**Department of Energy**

DOE-0193-06

**TRANSMITTAL OF THE ADDENDUM TO THE CERTIFICATION DESIGN LETTER  
AND CERTIFICATION PROJECT SPECIFIC PLAN FOR AREA 6 GENERAL AREA  
EAST**

FIGURE 1. AREA 6 GENERAL AREA EAST TANKER TRUCK SPILL CU LOCATION MAP

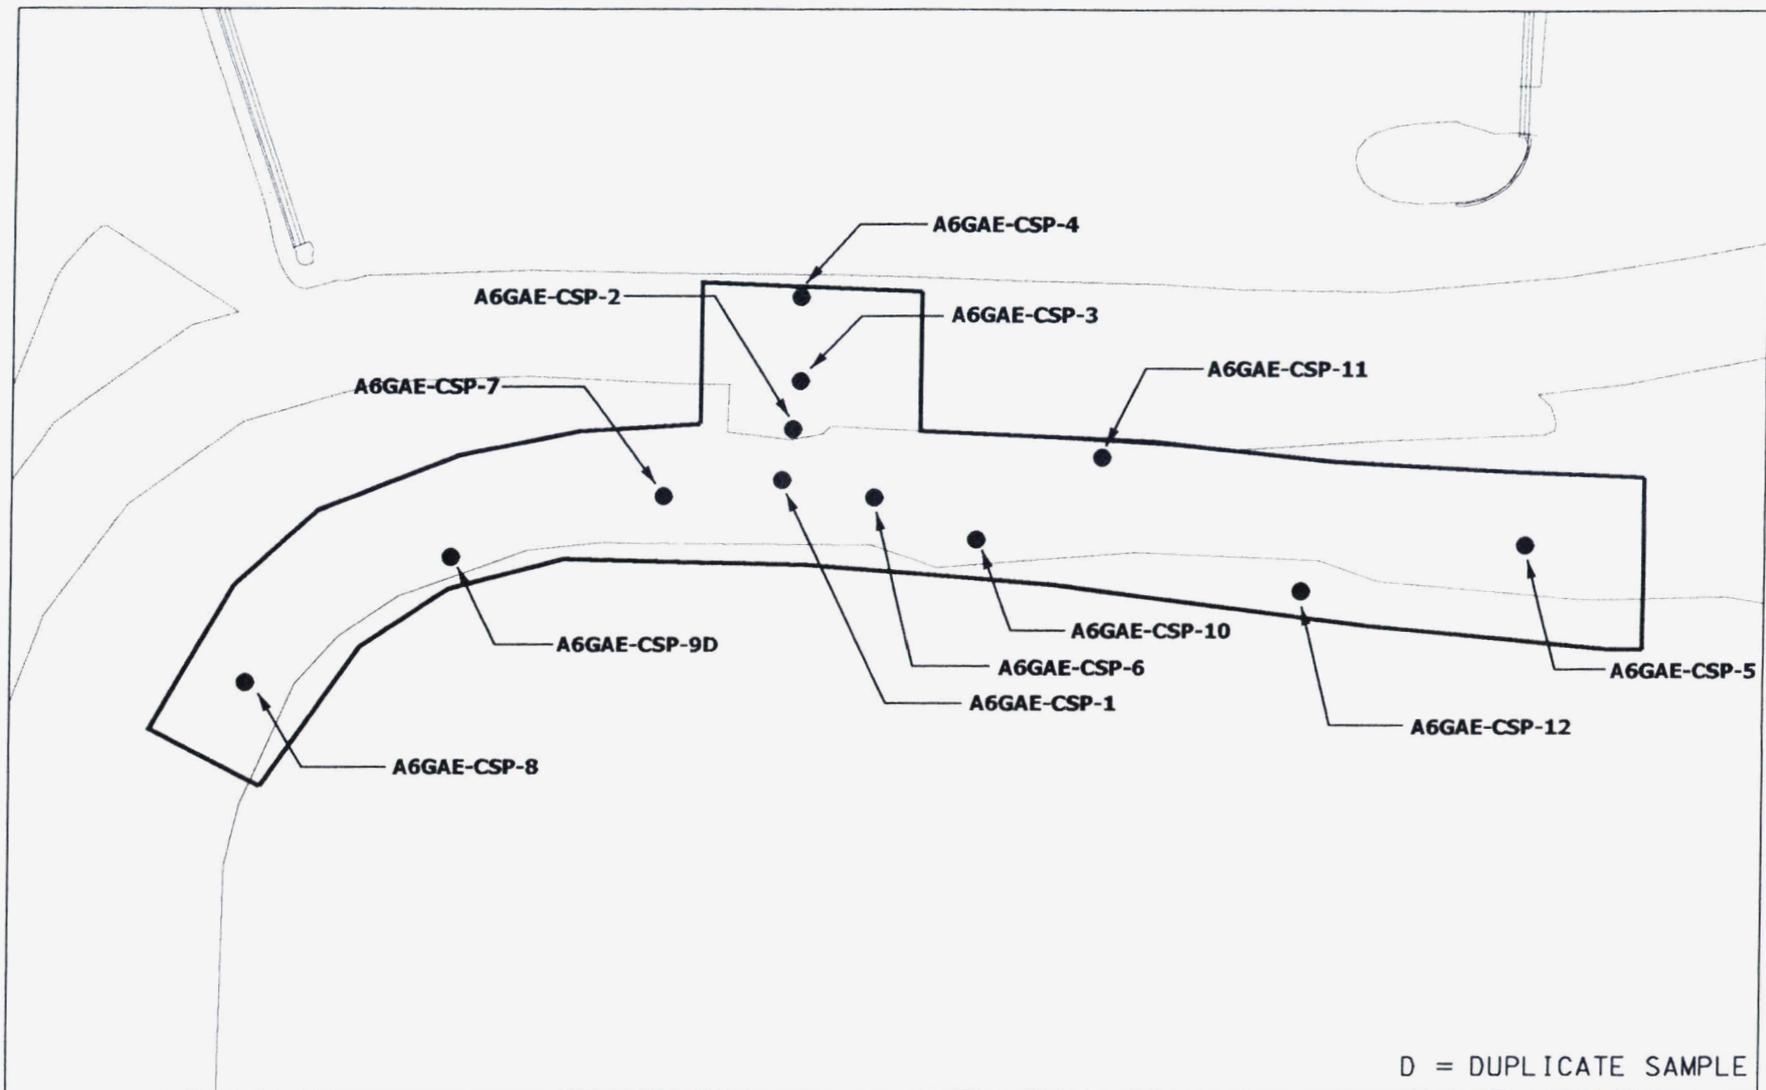
This letter and enclosures are being submitted for your review as a draft addendum to the Certification Design Letter (CDL) and Certification Project Specific Plan (PSP) for Area 6 General Area East (Document 20600-PSP-0018). The scope of this addendum is a small strip of land to the south of Soil Stockpile 7 (SP-7), to the north of Area 3B, and included as part of Area 6B and Area 3B Main Drainage Corridor (see Figure 1). This addendum is being submitted as outlined in Ohio Environmental Protection Agency Comment Response 7 emailed on August 9, 2006 and agreed upon by the OEPA on August 10, 2006 (References 2 and 3).

As with other certification units (CUs) in Area 6 General Area East, the certification design follows the general approach outlined in Section 3.4 of the Sitewide Excavation Plan. The scope of this addendum consists of one Group 1 CU for the footprint of the area affected by the spill. This CU design is shown in Figure 2. The overall certification design, sampling, analysis, and validation necessary to demonstrate that soil in this area has met the final remediation levels for all area-specific constituents of concern is presented in the CDL and Certification PSP. Specific information for the CU design of the area affected by the spill is contained in this addendum. The sub-CUs and sample locations presented in Figure 2 and Attachment 1 include the area affected by the tanker spill in Area 6 General Area East. The Sampling and Analytical Requirements as well as the Target Analyte List are included in Attachments 2 and 3 respectively. The Target Analyte Lists from both Area 6 General Area East as well as that of SP-7 will be used for this sampling event.

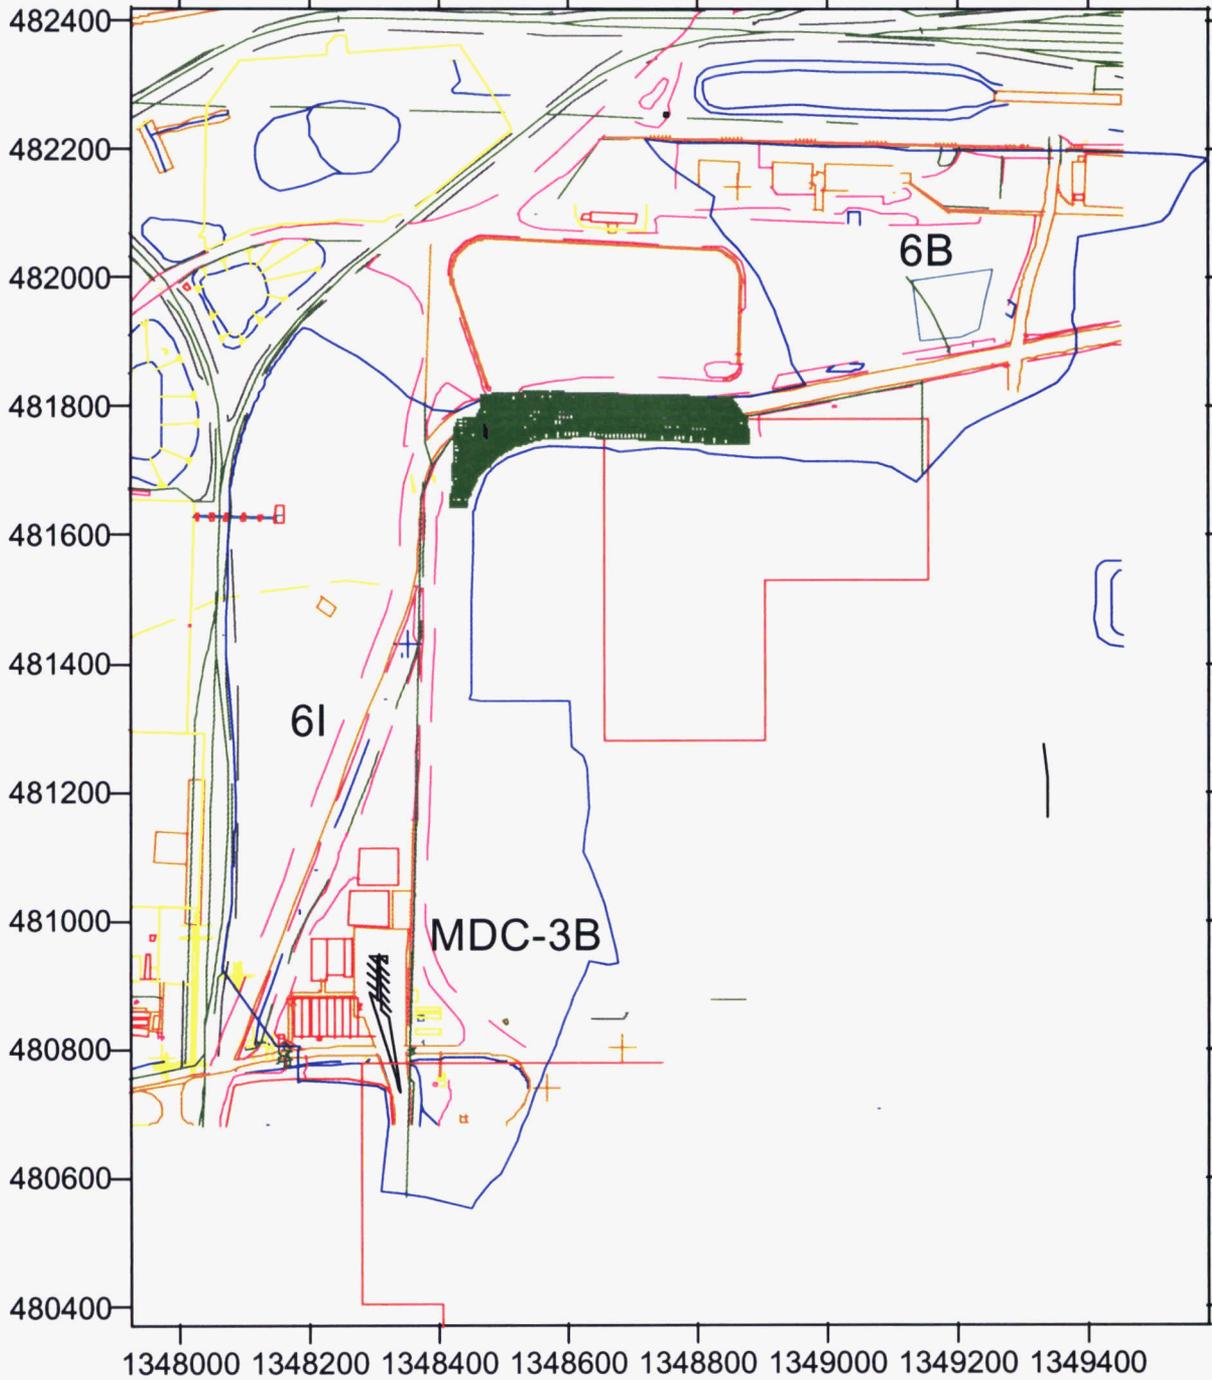
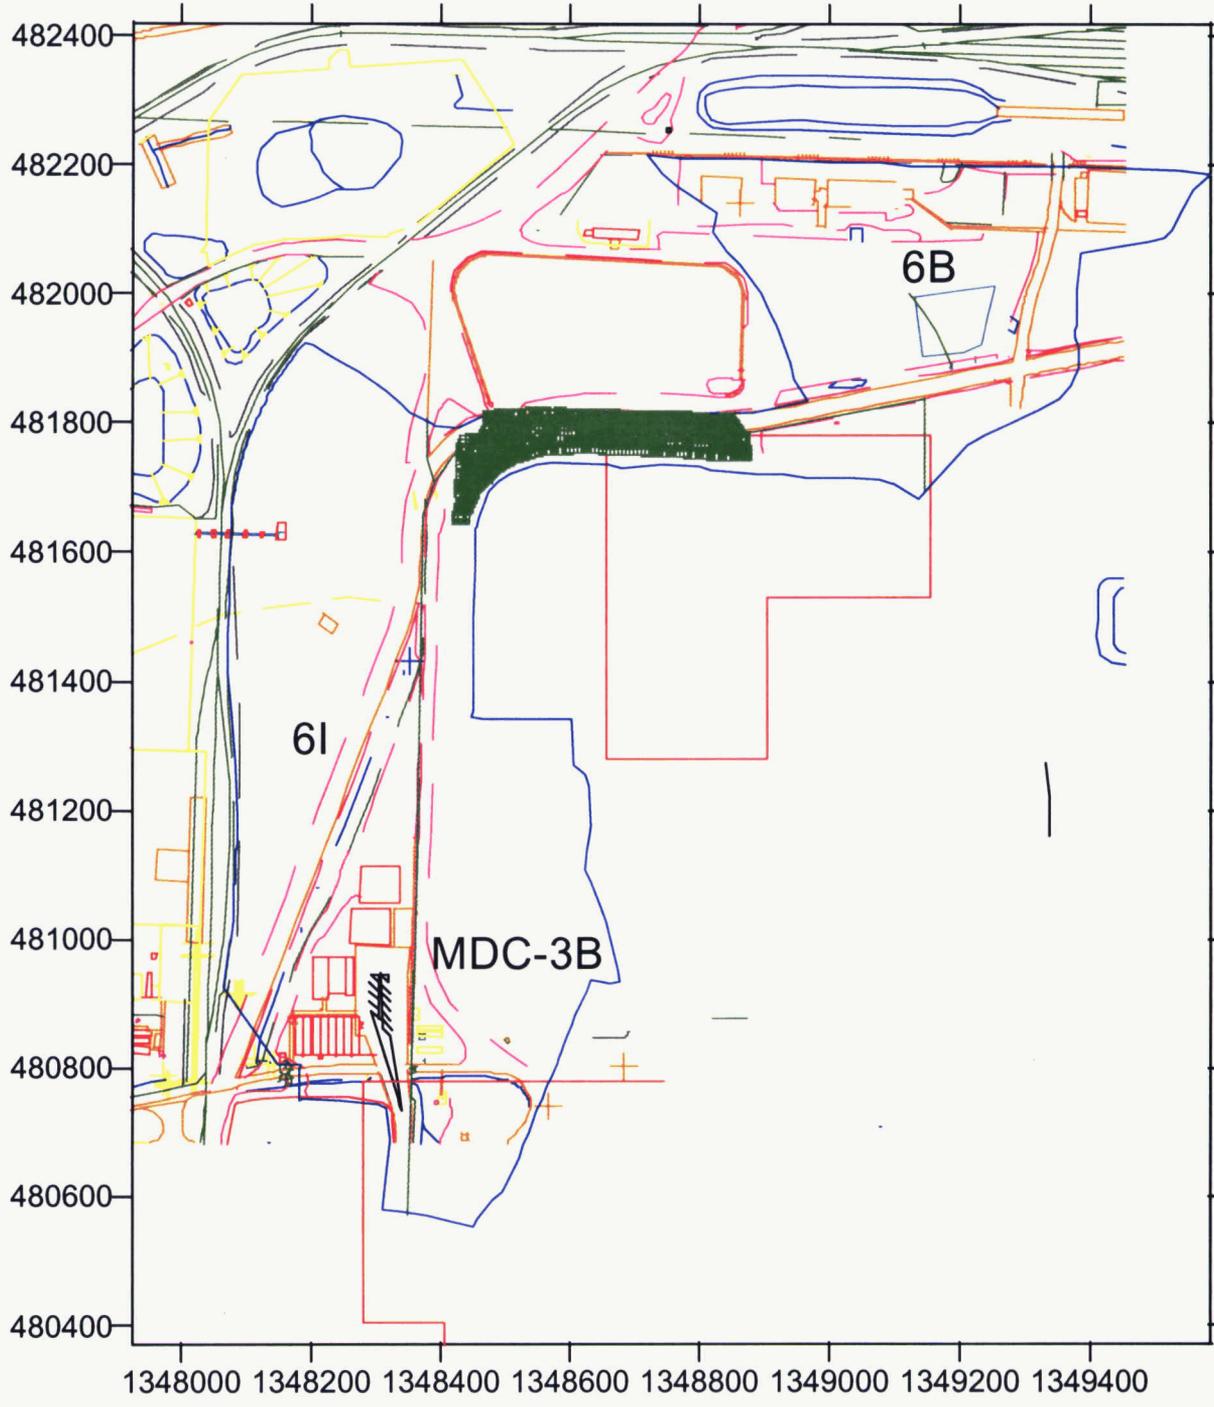
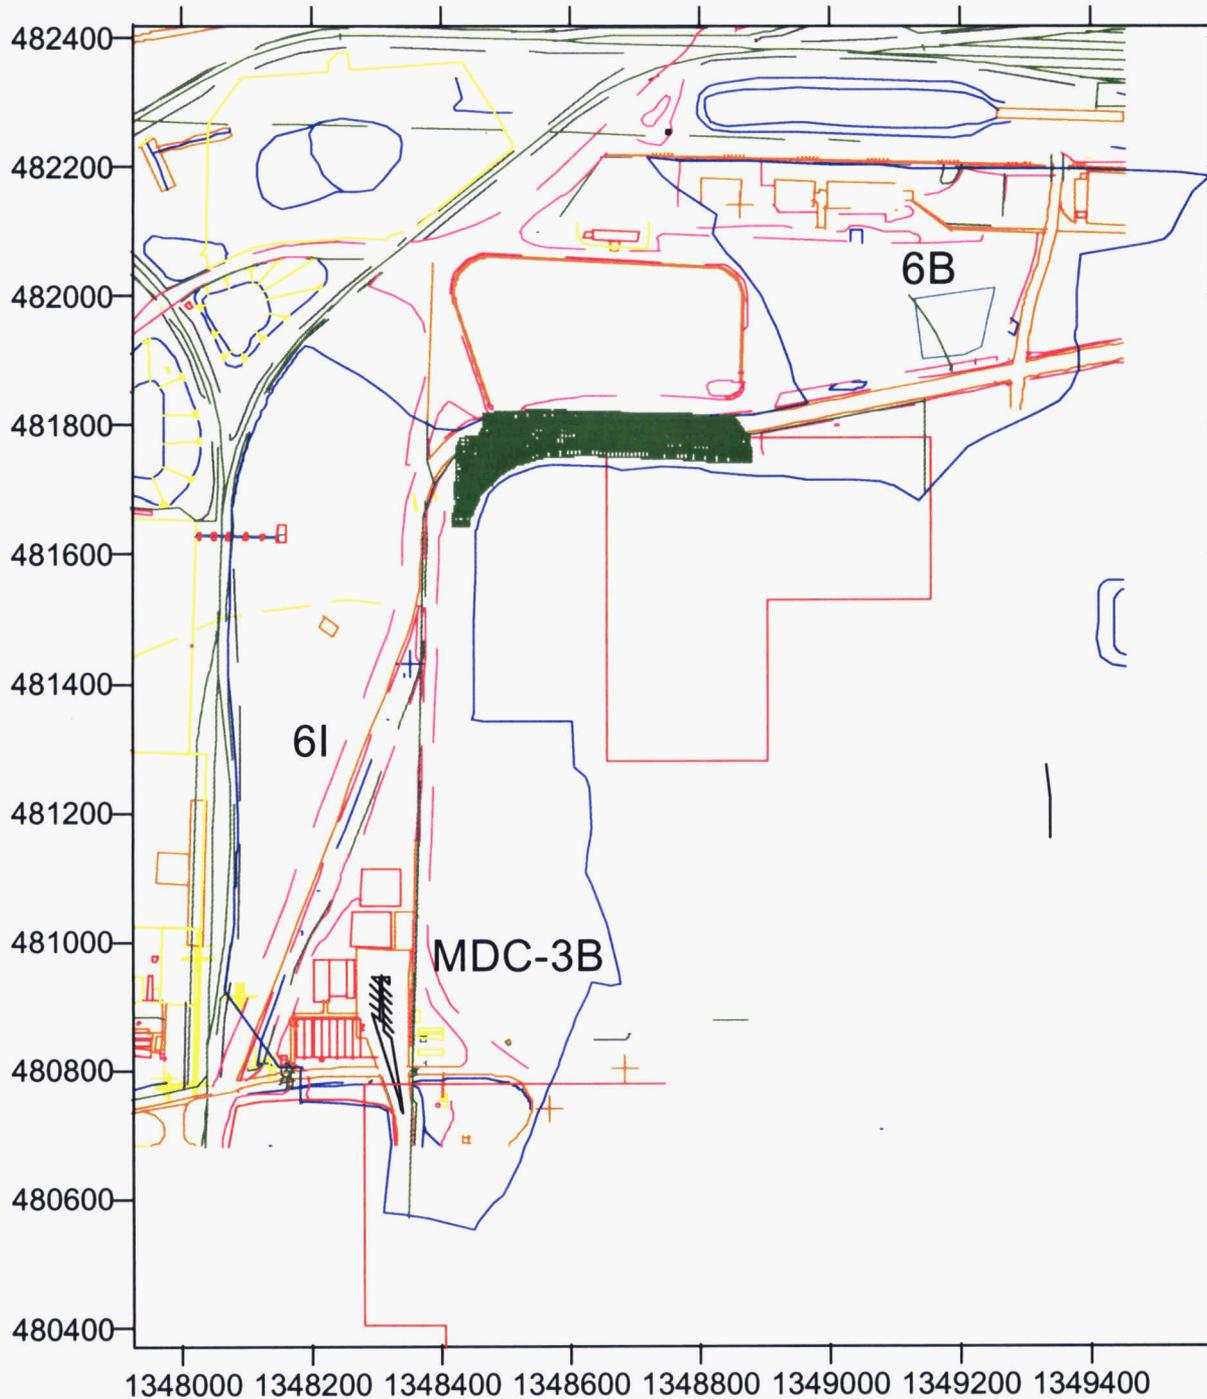
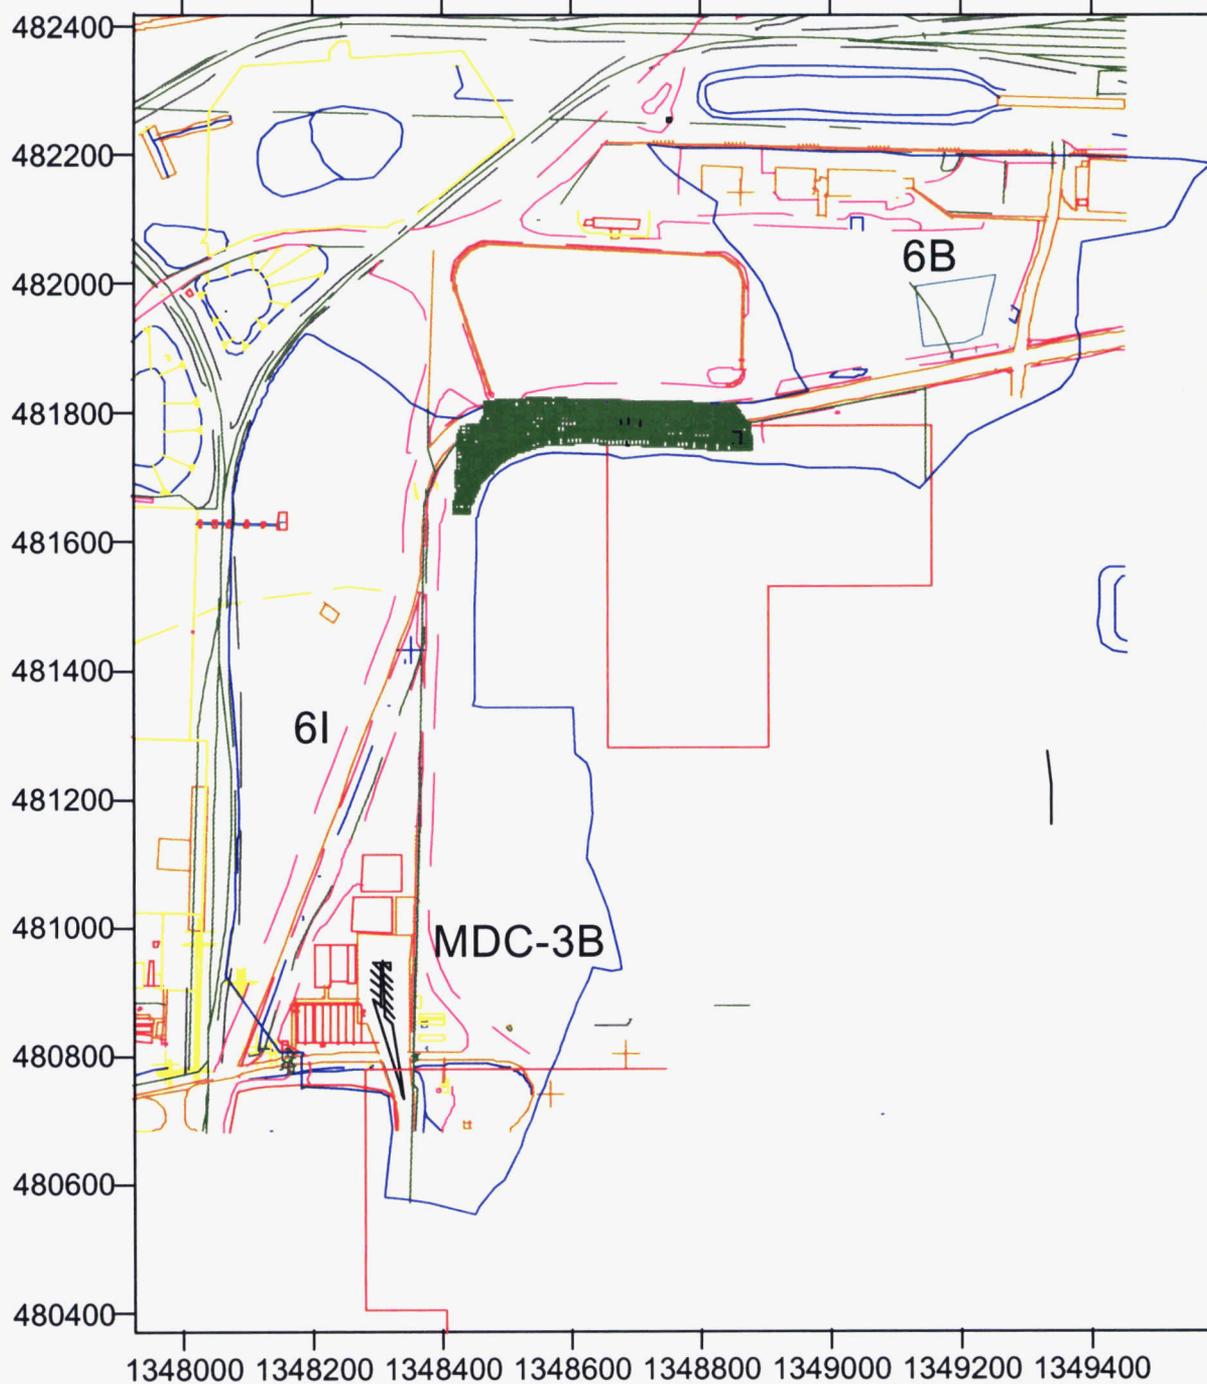
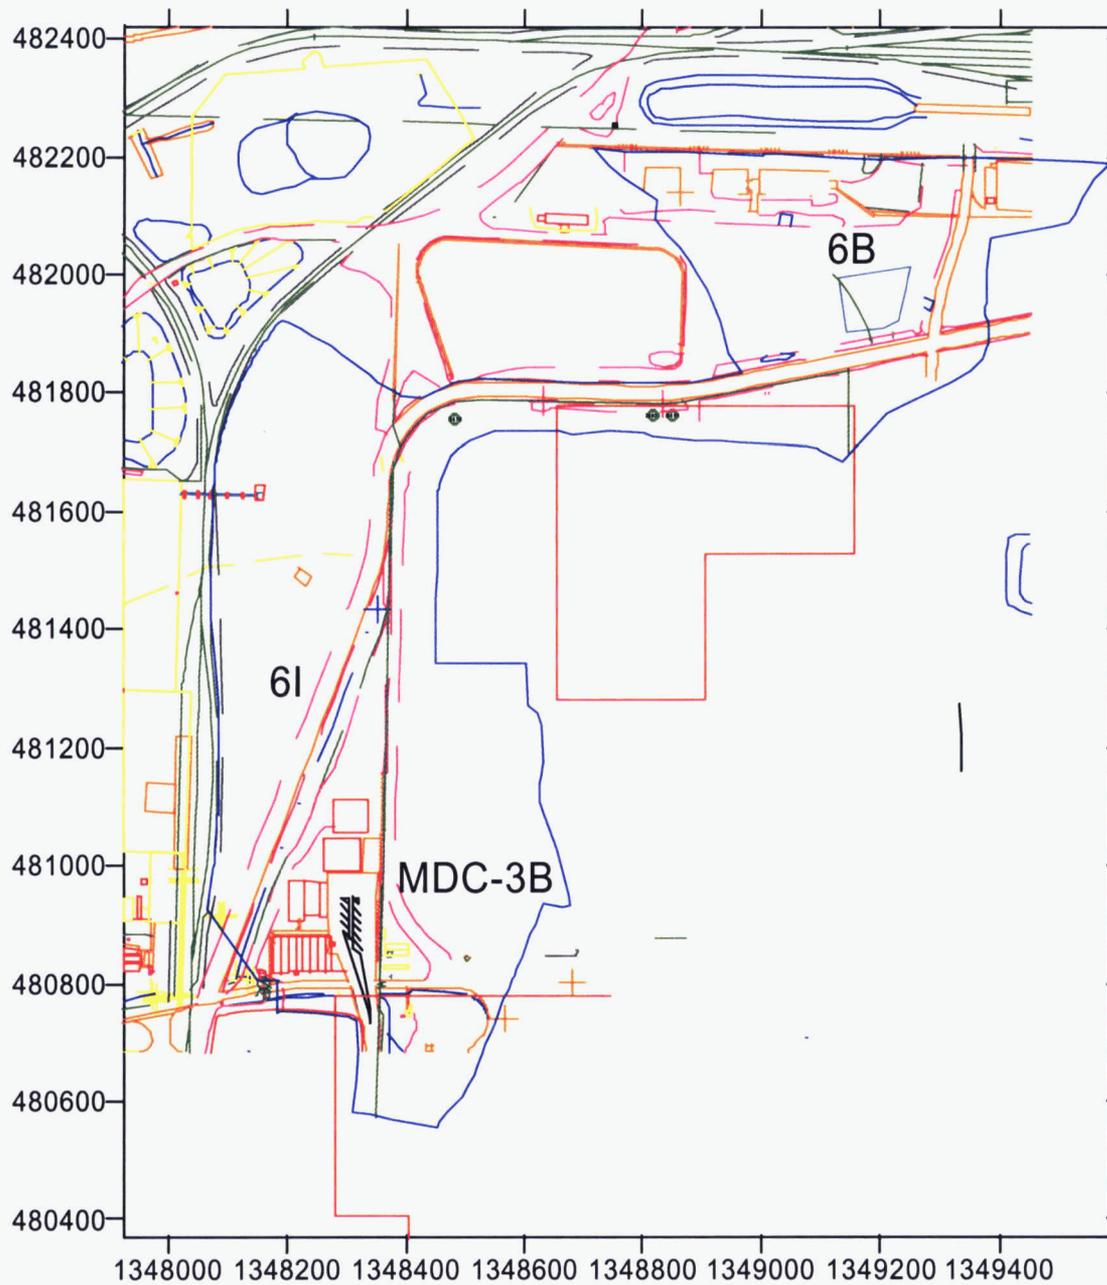
parameters (see Figures 3 through 9) and based on these results, it has been determined that no further remedial actions are required prior to beginning certification activities. The footprint will be restored immediately after the recertification.
